12 June 2024

SB Civil
C/-
Laila Alkamil
Senior Planner
Williamson Water and Land Advisory

RESPONSE TO ADDITIONAL INFORMATION REQUEST – 1618 ARARIMU ROAD, PAPAURA

Figure 1: Auxiliary Turn Lane Warrant Nomograph (Truck adjusted ecm/h)

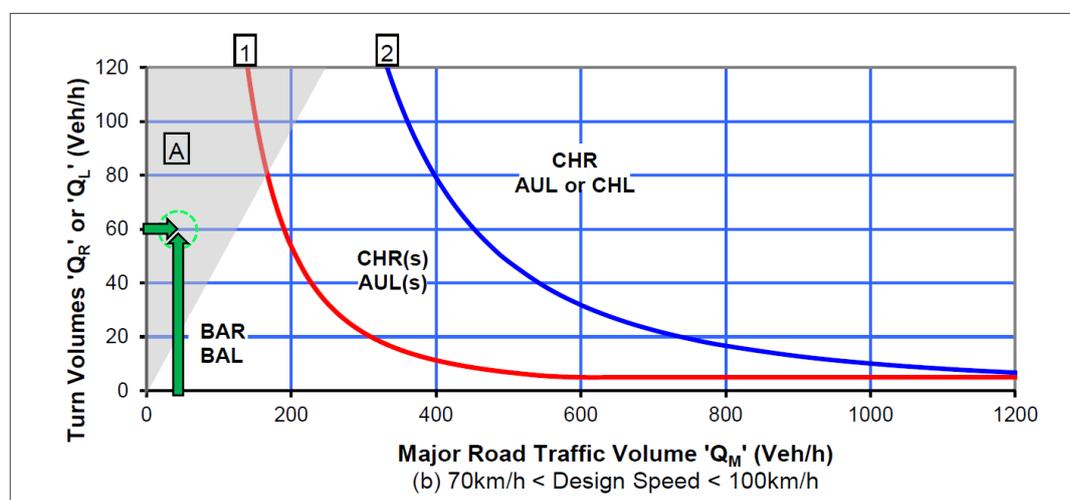
Given that truck traffic from the site is estimated around 58-87 trucks per day, or 348-522 equivalent car movements/day (ecm/d), AT considers that the proposed crossing should be considered as an intersection with high traffic volume in accordance with NZTA Planning Policy Manual Appendix 5B. Please provide an assessment of the access design in accordance with the relevant NZTA standards to ensure road user safety for Ararimu Road.

Further, when utilising the Austroads Warrant Nomographs and expanding for ecm/h for the site, the access is still below the threshold for the implementation of an auxiliary turn lane as shown in **Figure 1**.

From the warrant nomograph, with appropriate sightlines at the access location there is no considered need to provide an auxiliary turn lane at this access location.

Figure 2: Site Typical Haul Route

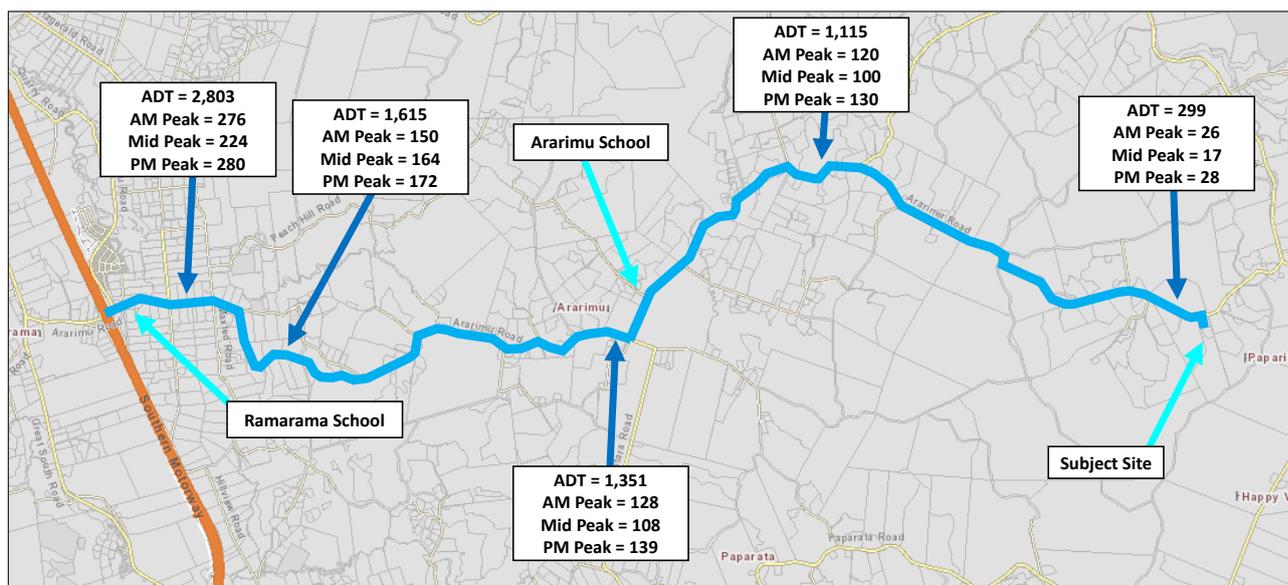
The TIA does not specify details regarding the predominant route which the trucks will be using to import earth to the site. It is assumed that the predominant route to the site will be via SH1 motorway with the Ramarama off-ramp located 15km west of the site. There are two schools (Ramarama School and Ararimu School) located on this route and there are potential adverse safety effects on students and the school community in relation to those schools due to the high number of truck movements which has not been assessed.

- a. Please advise the primary route(s) that trucks are expected to use to and from the site.*
- b. Please provide a safety assessment in relation to the schools, students and associated road users and any proposed mitigation measures to address potential road, pedestrian and cyclist safety.*

Trucks travelling to/from the site are largely anticipated to follow a direct route via Ararimu Road from SH1. This would see vehicle movements past both Ararimu School and Ramarama School as identified by Council within the RFI. **Figure 2** displays the primary route trucks would be anticipated to take, along with traffic volume estimates along the route.

At Ararimu School, the main access to school is off Steel Road. Along Ararimu Road near the school peak hour volumes are approximately 130-140 vehicles, with 11% medium and heavy vehicles. With the proposal adding up to nine peak hour truck movements, this would see the two-way volume along Ararimu Road, near Ararimu School increase to 150 vehicles, with 16% medium/heavy vehicles.

At Ramarama School, along Ararimu Road near the school peak hour volumes are approximately 280 vehicles, with 16% medium and heavy vehicles. With the proposal adding up to nine peak hour truck movements, this would see the two-way volume along Ararimu Road, near Ramama School increase to 290 vehicles, with 19% medium/heavy vehicles.

More specifically, at Ararimu School, additional truck volumes along Ararimu Road are not anticipated to adversely impact onto the overall safety/functionality in the area, as the intersection of Ararimu Road and Steel Road has generally good sightlines and targeted speed limit reductions during school peak periods.

Near Ramarama School, sightlines towards the school's frontage are good and a signalised pedestrian crossing is provided allowing pedestrians to safely cross Ararimu Road. Similarly, targeted speed limit reductions during school peak periods are present. The increased of trucks along this section of road is not anticipated to adversely impact onto the overall road safety, noting the relatively low volumes (9 per hour, or one every 6-7 minutes), and the reduced operating speeds.

From the above, it is not considered that any mitigation measures would be required near Ararimu School or Ramarama School in response to the proposal.

Sheet Title **Proposed Vehicle Crossing Arrangement**
 Vehicle Tracking - 17m Dump Truck and Trailer (500mm Clearance)

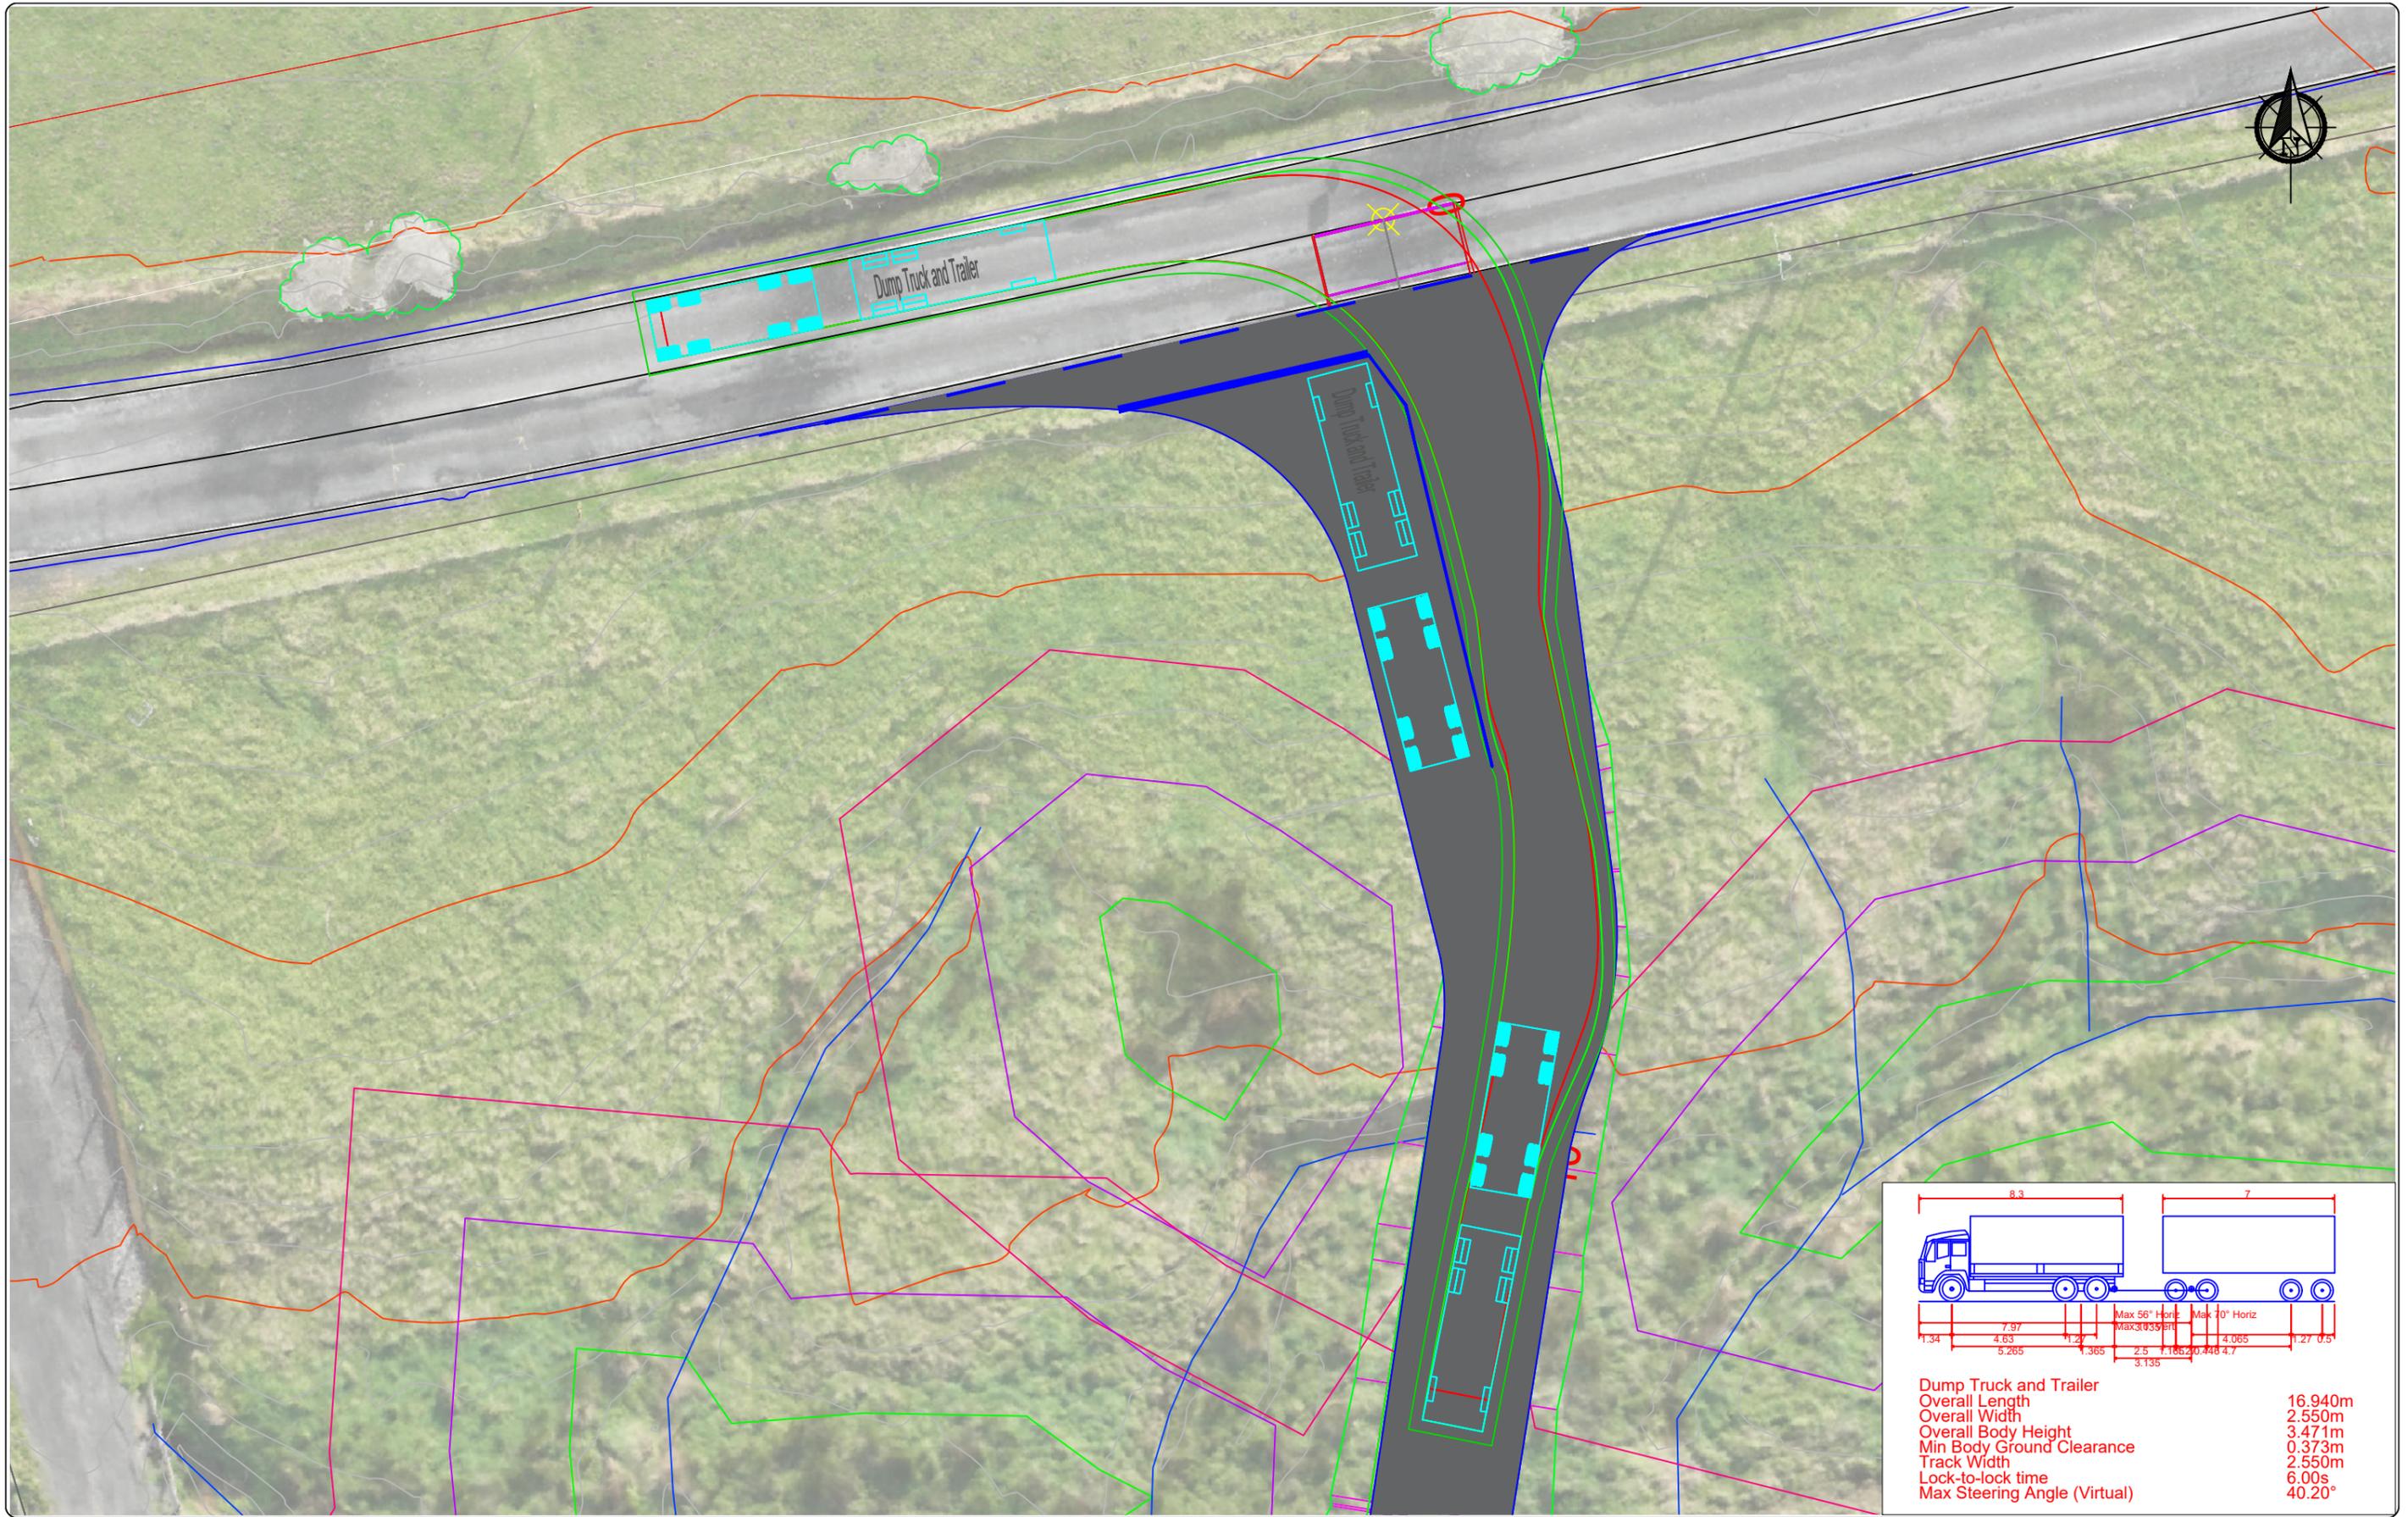
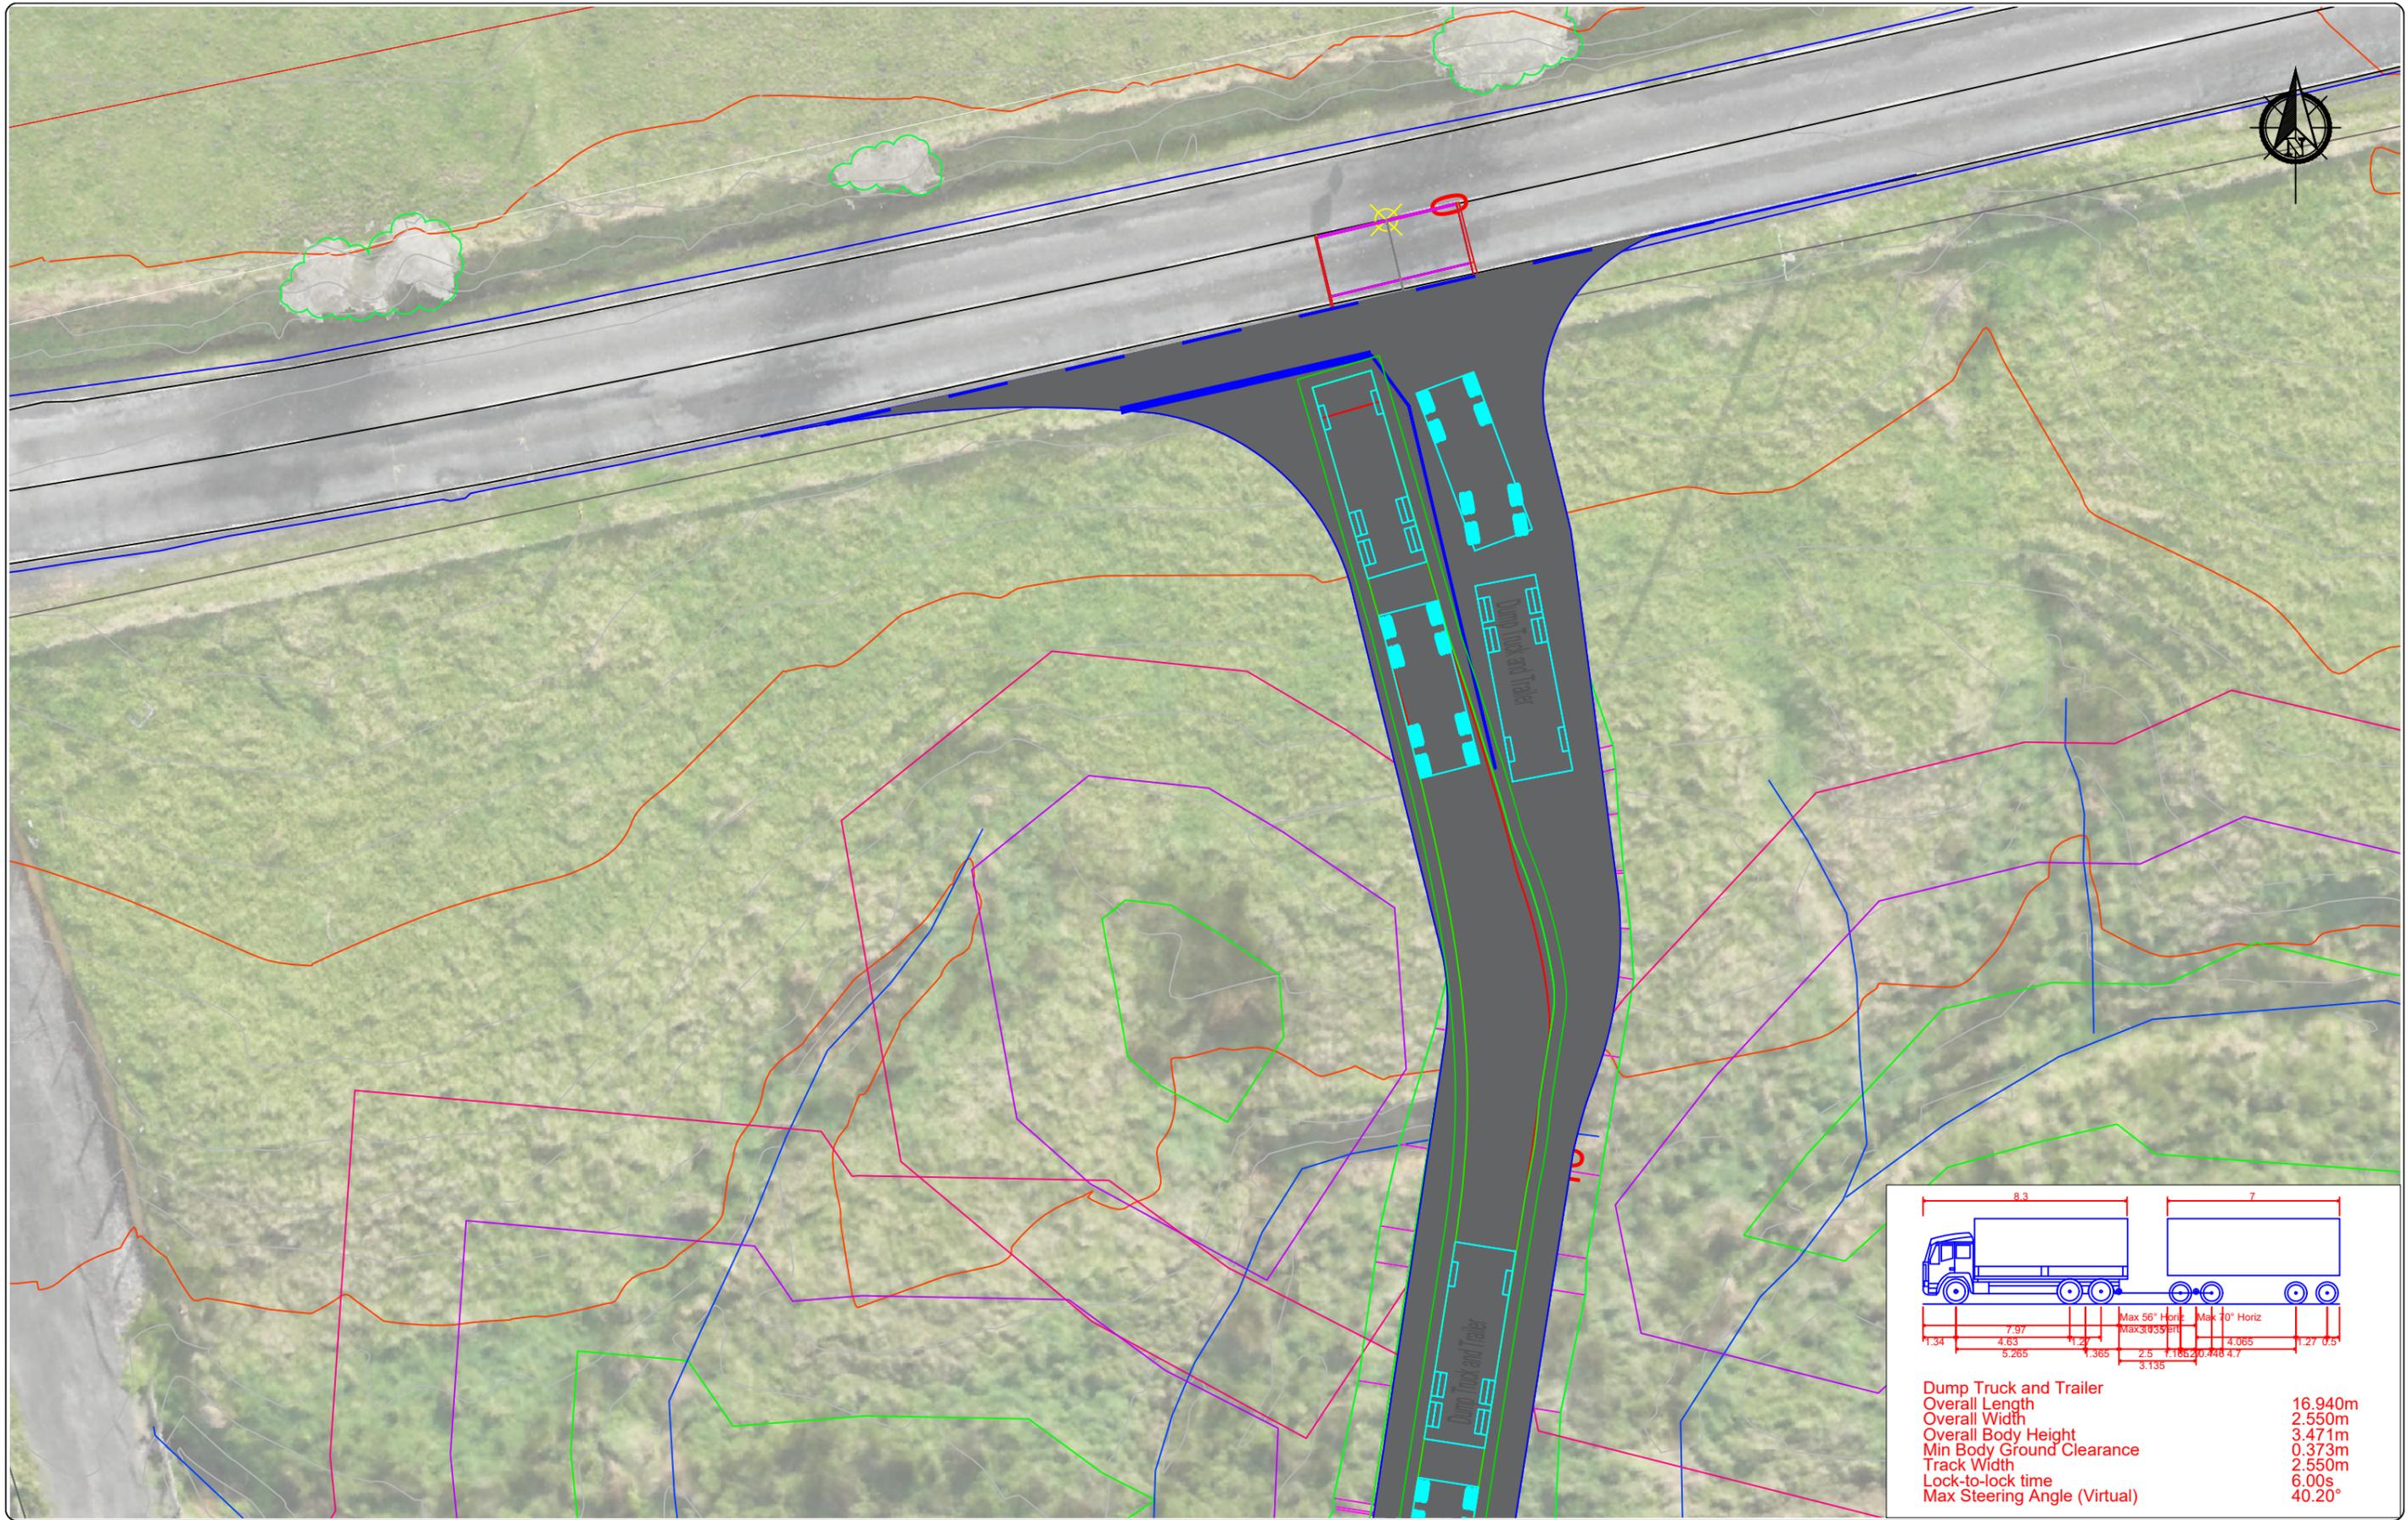
Please provide tracking of the 17m Dump Truck and Trailer around the bends of the internal driveway to ensure truck stays within the internal driveway.

Vehicle tracking curves for the internal access have been prepared and are included in the **Attachment**.
